**COMMENTS OF THE GREEN POWER INSTITUTE  
ON THE 2026-2028 WILDFIRE MITIGATION PLAN OF PG&E**

May 23, 2025

**COMMENTS OF THE GREEN POWER INSTITUTE  
ON THE 2026-2028 WILDFIRE MITIGATION PLAN OF PG&E**

**Figure 1.** Reproduction from PG&E 2026-2028 WMP.

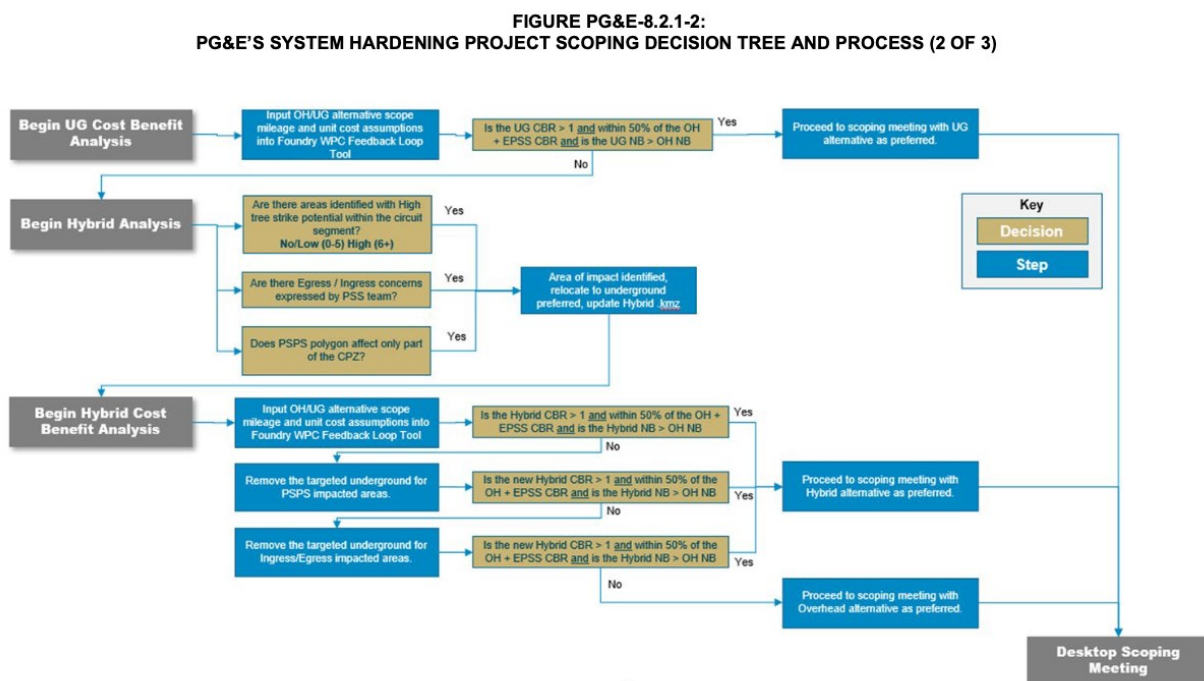
PG&E’s system hardening project scoping decision tree (2 of 3, Figure 1) further advances its Undergrouding-first paradigm. The process begins with an “UG Cost Benefit Analysis.” While the first step suggests an alternative OH versus UG mitigation assessment, the Decision steps are designed to advance UG mitigations over lower-cost OH+EPSS. Seven decision steps are used to select UG versus OH hardening:

UG CBA, Criteria 3 (UG NB > OH NB) invokes net benefit, which we assume is the NPV of Risk Reduction – NPV of program costs. The NB calculation is missing from the WMP and PG&E should be required to provide it in a Revision Notice that includes a stakeholder review opportunity. Screen 3 essentially sets a very low risk tolerance threshold that approves undergrounding based on its ability to provide any margin of net benefit over OH+EPSS. This means, an undergrounding project that is twice the cost of OH+EPSS but offers even a < 1% margin of additional risk reduction will be preferred. This is not an appropriate risk tolerance or planning standard as it fails to balance ratepayer safety, reliability, and affordability. This criteria should be rejected and PG&E should be order to propose an alternative risk threshold for UG selection that directly relates to catastrophic wildfire risk exposure.

The PSPS polygon criteria is presumably a binary Y/N option and does not clarify the data source. It does not appear to be based on the PSPS risk model output. Assuming this is based on actual PSPS event polygons (e.g. versus a 10-year backcast) we interpret this to mean that a CPZ would qualify for UG if a single PSPS event polygon overlapped part of the CPZ or impacted very few customers, including prior to updated PSPS event criteria and sectionalizing that has reduced PSPS frequency, scope, and duration.

All three of these “re-qualifying” criteria completely disassociate UG investments from CBR and permit extremely low and subjective risk tolerance thresholds for UG versus OH system hardening. Amusingly, the Decision flow does not offer an optional “No” path, indicating the only “right answer” is “Yes” UG. There is no other mitigation option pathway. At the bare minimum, PG&E should be ordered to clarify the risk tolerance thresholds and decision criteria and add a “No” decision tree path. We provide additional recommended improvements below.

Hybrid CBA: The re-added undergrounding CPZs are then passed through the same low-bar CBR and NB Criteria as in the UG CBA, but for a hybrid OH+UG scope. It's not clear at what resolution each CPZ is hybridized. For example, is UG added/removed in 1-mile segments or based on risk model resolution? Regardless, the Hybrid CBA sequence is built to retain as much UG scope as possible through incremental removals, while still passing its low-bar CBR and NB thresholds. UG scope is first removed based on PSPS impacted areas, which is an illogical risk-based decision since UG is the only mitigation that could eliminate PSPS event risk (if carefully sited).

PG&E should be ordered to revise its system hardening project scoping decision tree to provide the recommendations detailed above. PG&E's system hardening project scoping Decision tree should advance a paradigm of balanced safe, reliable, and affordable service, as well as least-cost best-fit investments.

**Figure 2.** Calistoga substations and planned WMP system hardening mitigations.<sup>106</sup>

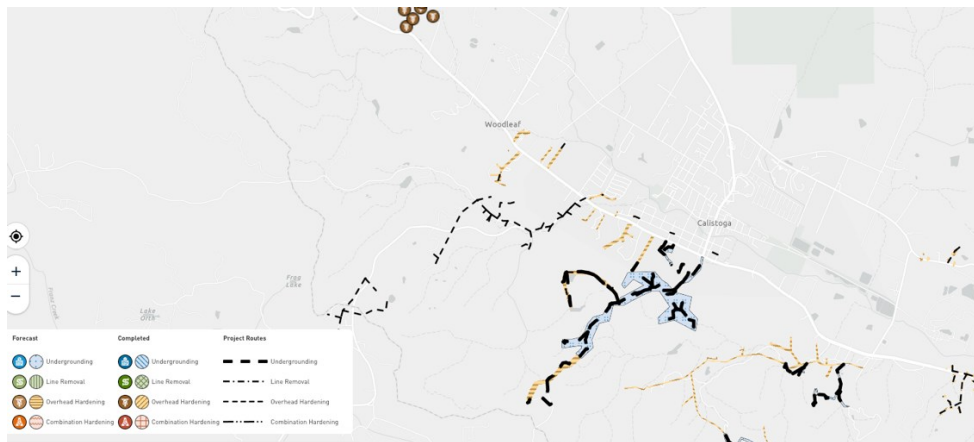
Calistoga substation and its feeders (1101 and 1102) are a case study in integrated planning as it pertains to the confluence of wildfire mitigation and distribution system planning. On the wildfire mitigation front, PG&E has deployed REFCL, sectionizing, overhead hardening (CC + poles), EPSS enablement, and PSPS events. Planned risk mitigation investments include additional overhead system hardening and a patchwork of undergrounding that will be deployed along existing RECFL protected lines. This is also the site of PG&E's Calistoga Clean Substation Microgrid, which will supplant the temporary microgrid.<sup>104</sup> The Calistoga substation is also the site of identified grid needs in the distribution planning process and is slated for a new Bank and Feeder installation this year (2025) to address increasing capacity needs and peak loading exceeding 94 percent by 2028 (\$8.2M). Existing and Queued distributed generation on

the two existing feeders total 8.2 MW and 22.9 MW, respectively.<sup>105</sup> It is unclear whether the Queued distributed generation includes the Calistoga Clean Substation Microgrid or if the permanent microgrid triggered the distribution system upgrade. If the microgrid triggered the system upgrade, the cost of the distribution system upgrade is essentially a part of the granular ratepayer CapEx wildfire-reliability risk investment.

PG&E’s only REFCL pilot is located at the Calistoga Substation and acts on its 160 primary distribution circuit miles. In their 2026-2028 WMP they report that the pilot “continues to progress but is still currently in the testing and evaluation stage.” Staged fault testing in 2023 was successful. However, REFCL was only enabled 15 percent of the time in 2024. Although there have been no ignitions while REFCL was enabled, they report that the pilot has not generated sufficient data to calculate wildfire risk reduction effectiveness.<sup>107</sup>

**Figure 3.** HFTD Tier 2 and 3 zones overlain with PGE Transmission Lines showing potential scope of Advanced Conductor deployment in the HFTD. Source: PG&E Grid Resource Integration Portal, Accessed April 17, 2025.<sup>115</sup>

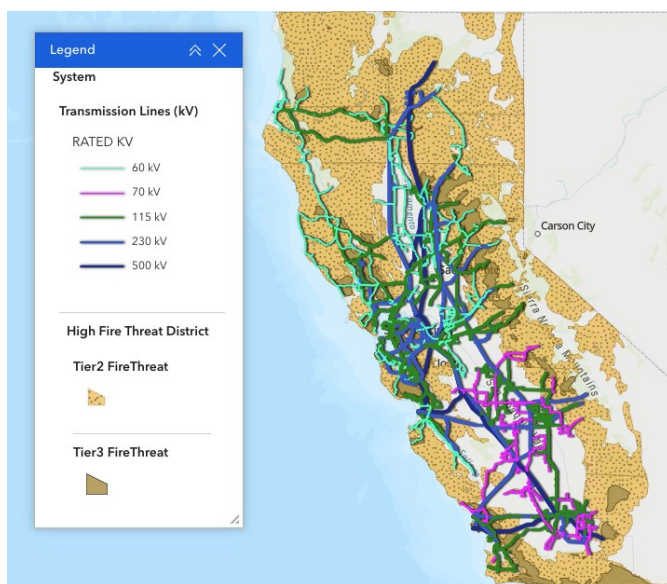
the coming years.<sup>e.g.113</sup> Advanced conductors may offer a solution to quickly increase transmission capacity and mitigate line losses along some existing transmission lines, while also reducing the land-use impacts and wildfire risk associated with transmission system footprint, and offering a bridging strategy for 10+year timelines to approve and install new transmission lines.

PG&E and SCE have sought funding to upgrade over 400 miles of steel core transmission lines with carbon fiber or composite core advanced conductors.<sup>114</sup> It is possible that reconducted transmissions lines with Advanced conductors will, or already do, cross HFTD regions. For example, many of PG&E's transmission lines cross through HFTD Tier 2 and Tier 3 regions (Figure 1), connecting high resource potential lands (e.g. desert and basins) to population centers.
